# RE539279

The WIX 57750S is **NOT** the correct replacement filter for applications that require the JD RE539279 filter.

Larger Inner Sealing Diameter

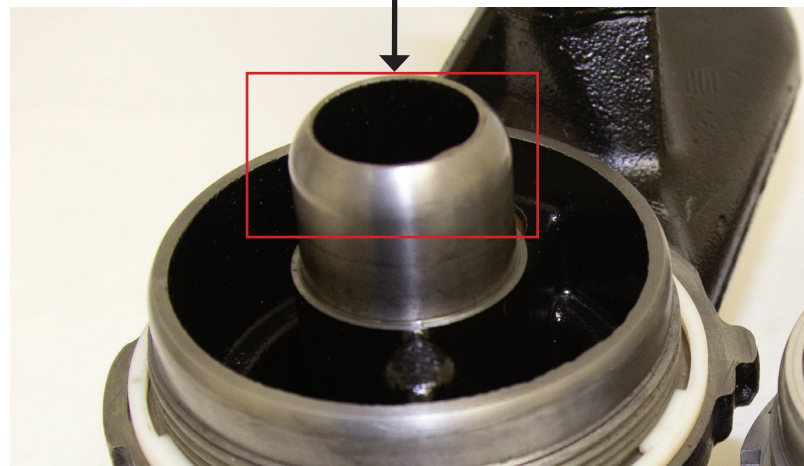
The RE539279 filter (not currently available through WIX) has a larger inner seal diameter and is therefore not interchangeable with the WIX 57750S.

Use current catalog information and application details to ensure correct filter selection.
